PCN# : P693AAB
Issue Date : Sep. 09, 2016

Information Only Notification

Figure 10. Maximum Continuous Drain Current vs Case Temperature

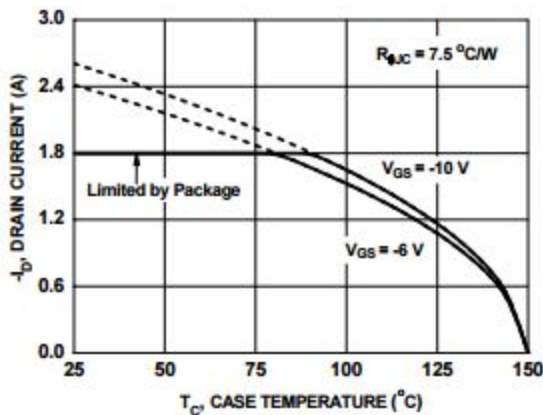
1. MOSFET max ratings: (page 1)
 - Continuous ID Tc=25C from -1.8A
 - No continuous ID at Tc=100C;
 - Pulse ID from -2A
4. Figure 10, Maximum Continuous Drain Current vs. Temperature was limited by package limit (Page 4)
5. Figure 11 Safe Operating Area curve, pulse current is -2A, and continuous current is limited by package limit. (Page 4)

- Add continuous ID at $T_c=100^\circ\text{C} = -1.65\text{A}$
 - Pulse ID updated to -9A based on $100\mu\text{s}$ transient thermal calculation.
- Updated Figure 10 to remove package limit;
 - Updated Figure 11 SOA curve, pulse current to -9A based on $100\mu\text{s}$ calculation and continuous current not limited by package limit.
